Centre Wellington Scoped Tier 3 Water Budget Study: Discussion on draft Groundwater Flow Model Development and Calibration Report

Meeting Objective: To discuss and provide clarification to comments provided by S.S. Papadopoulos & Associates on behalf of Nestlé Waters Canada (NWC) on the draft Groundwater Model Development and Calibration Report prepared as a part of the Centre Wellington Scoped Tier 3 Water Budget Study.

Subject: Centre Wellington Scoped Tier Three Water Budget Assessment

Review comments on the draft Groundwater Flow Model Development and Calibration Report

Figure 3. DDH-05 profiles of hydraulic head (data from the Ontario Geological Survey)

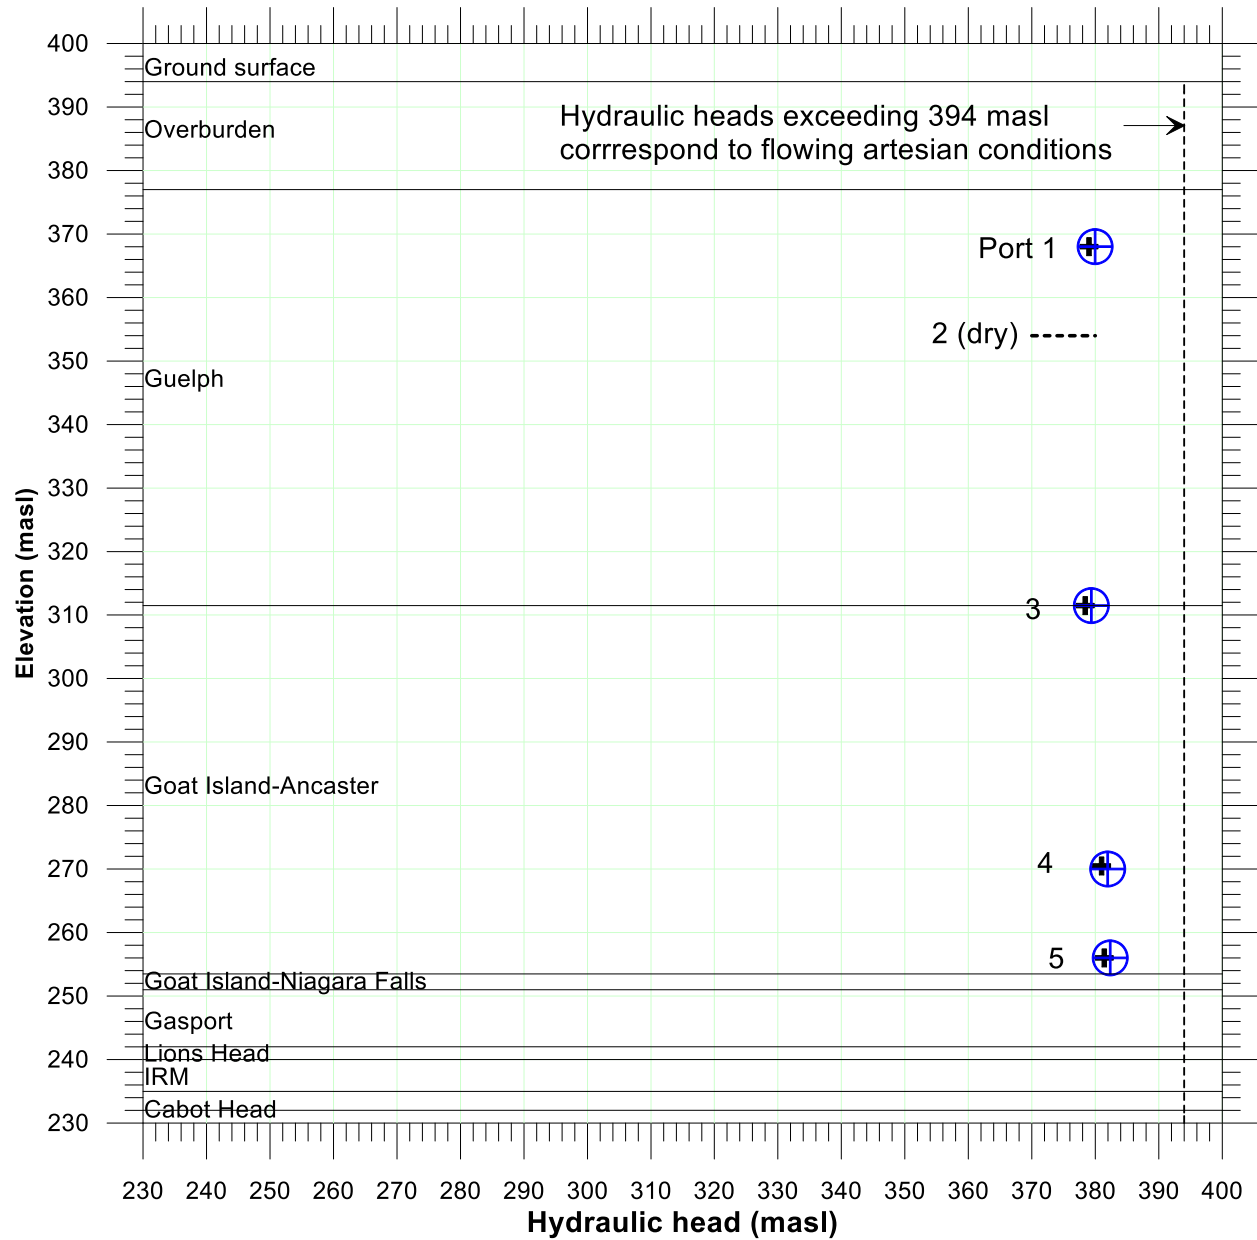
1. The data from a high-quality Ontario Geological Survey (OGS) multilevel well close to the Middlebrook well do not appear to have been included in the analyses.

The OGS borehole DDH5-09 is not indicated in the figure that shows the high-quality wells that have been considered in the calibration. Elizabeth Priebe has indicated to us that the data from two rounds of water level measurements have been provided to the study team. In Figure 3, profiles of hydraulic head from the two rounds are superimposed on the stratigraphic interpretation of Brunton and Brintnell (reproduced in Priebe and Lee, 2016). Continuous water level data have also been collected but are not yet available (E. Priebe, personal communication August 1, 2018).

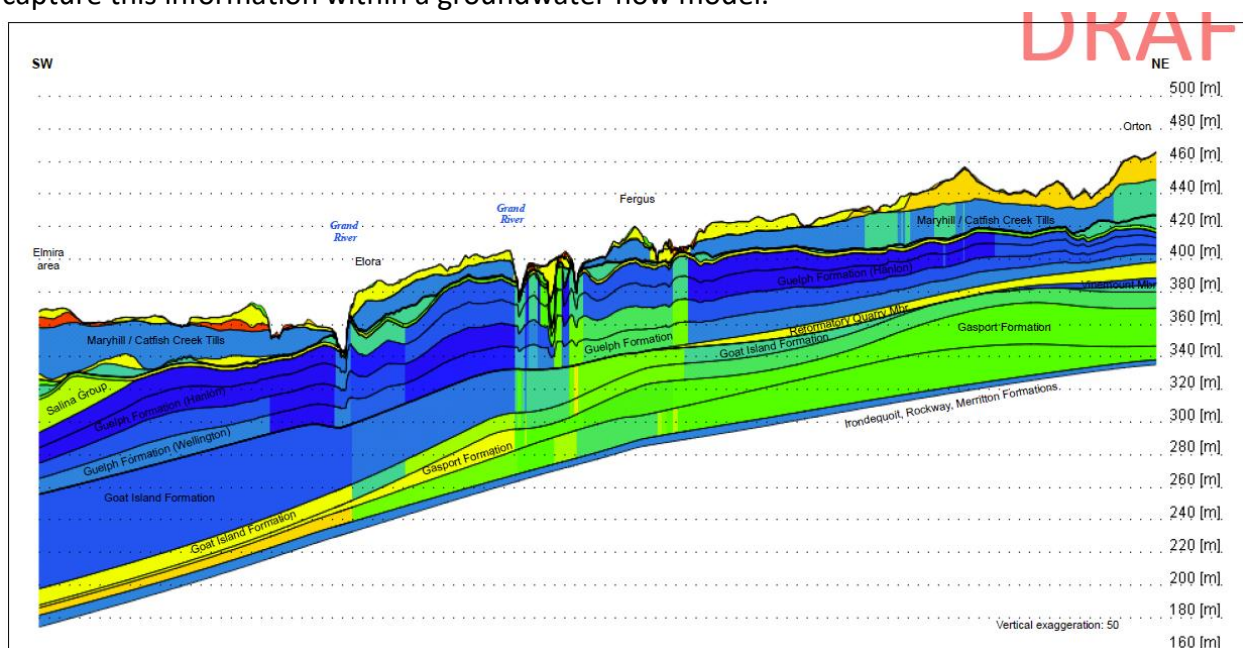
The flow profile and photos from the downhole video collected in the Middlebrook well show that the flow to the long open-interval well is limited to a zone at the lowermost 2 m of the well (Lotowater 2015b). Lotowater describe this zone as a “cavern”. This zone is interpreted to provide over 95% of the water that enters the well. Based on cross-section through the model, reproduced here from Figure 15 of the report, we place the water-producing zone of the Middlebrook well at the bottom of the Goat Island Formation. How is the well simulated in the model? Is the well effectively open across only model layer 19, consistent with the results from the flowmeter profiling or is the well simulated to be open across its entire length, and the model correctly simulates that the flow is concentrated at its bottom?

Frank Brunton (OGS) interprets the lowermost production zone in the Middlebrook Well, and the fracture zones noted in the municipal pumping wells as evidence of karst in the Study Area. The borehole log of DDH-05 presented in Brintnell (2012) includes references to fracture zones within the well as “karst” or “rubble zones.” These areas with enhanced fractures exist at many boreholes within the Study Area; however, mapping the three-dimensional continuity of these zones of enhanced transmissivity is difficult due to the irregular nature of bedrock fractures and the limited extent of high quality data outside the Fergus and Elora areas. As it is difficult to map in three dimensions the locations and spatial distributions of these zones, it is difficult to capture this information within a groundwater flow model.

Matrix noted that the Middlebrook well is not simulated as a well or an open conduit. Matrix provided an overview of how the model was calibrated to observations at the Middlebrook well, and responded to SSPA's concerns about over-simulation of drawdown at the Middlebrook well. Matrix hypothesized that including a strong karstic zone at depth would reduce the simulated drawdown at the Middlebrook well, but that is not yet implemented in the model.

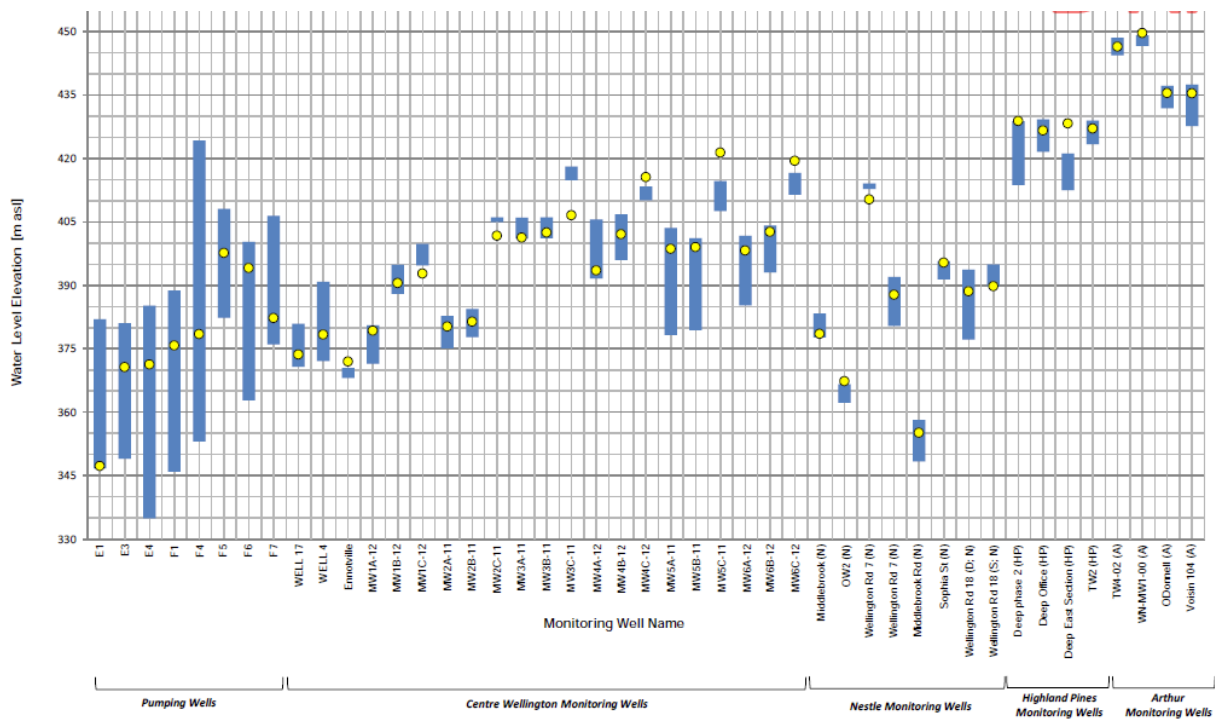
Figure 10 of the draft modeling report shows the match to the “higher quality wells”, with the Middlebrook well included among the 8 Nestlé Monitoring Wells. The reported simulated water level for the Middlebrook well is about 378.5 m asl, with the observations reported to range from about 378 m asl to 383 m asl. It is not clear what these levels represent.

Figure 3. Conceptual model for shallow and deep bedrock levels at the Middlebrook well

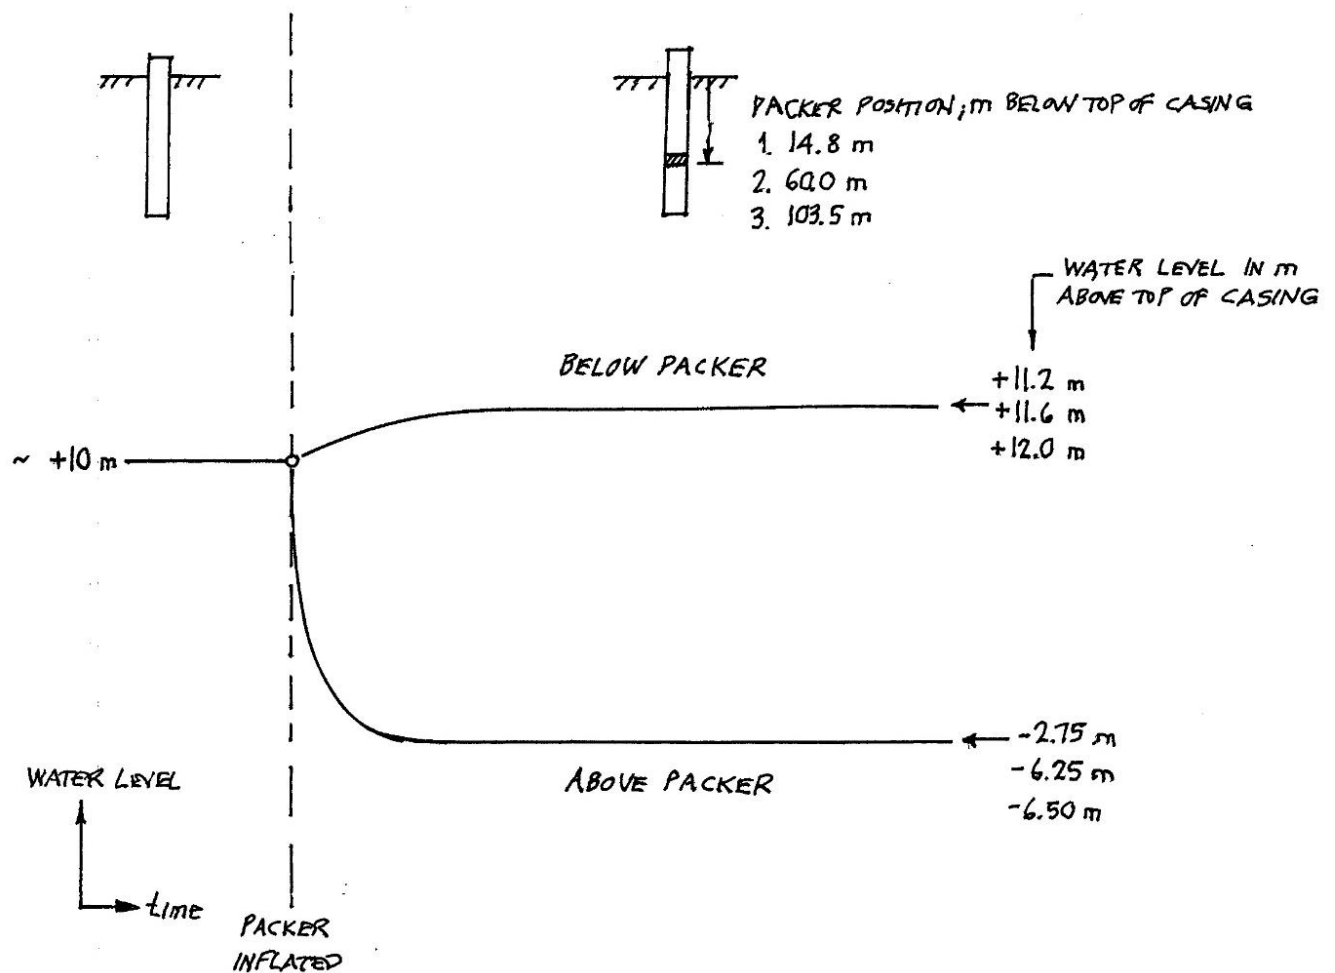
Referring to Gartner Lee (2005), the shut-in (i.e., non-pumping) water level in the Middlebrook well is about 15 m above ground surface (the well logs at the time of completion of the well report 47 ft above ground surface, and 20.5 psi [47.3 ft]). For a ground surface elevation of 365 masl, this corresponds to a hydraulic head of about 380 masl. This represents the composite water level for the long open interval of the well. The packer testing conducted by Lotowater (2015) showed that when the water-producing zone at the bottom of the well is isolated, there is a head differential of about 14 and 17 m between the water-producing zone and the shallow bedrock. Our interpretation of the separation between water levels when the flow zone at the bottom of the well is isolated, or the averaging of water levels when it is not, is illustrated here in Figure 3. Has any attempt been made to match the data and the well discharge rate observed under flowing conditions?

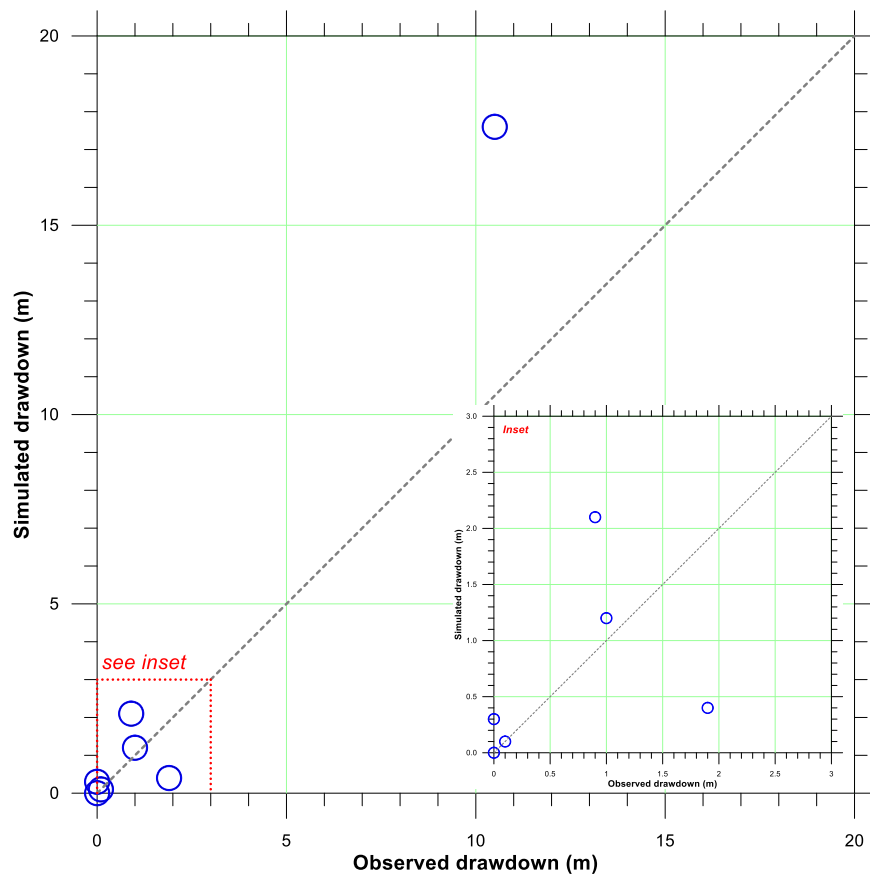
On Table 5 of the report (page 33). Matrix Solutions refer to “Simulated and Observed Drawdown during the 30-day Middlebrook Pumping Test”. What does “during” mean? Are these the simulated drawdowns at the end of 30 days? We are not convinced that they have as good a match as they claim. It is noted in the report that the model does not reproduce conditions around the pumping well. This is important, as the drawdowns in the well are so much larger than the drawdowns observed at the other observation locations. The observed drawdown (and it is really a stabilized drawdown) is 10.5 m, while the simulated drawdown of 17.6 m is much larger. It is indicated in the report that conditions around the Middlebrook well are a “local feature” and that the equivalent porous medium approach used in the study was able to represent the hydraulic responses in the larger groundwater flow system. We are not convinced. The matches to the observed drawdowns at W2 and W4 are not very close either. Our understanding is that one of the objectives of the Tier 3 model was to represent conditions at the Middlebrook well reliably; in our opinion this objective has not yet been accomplished.
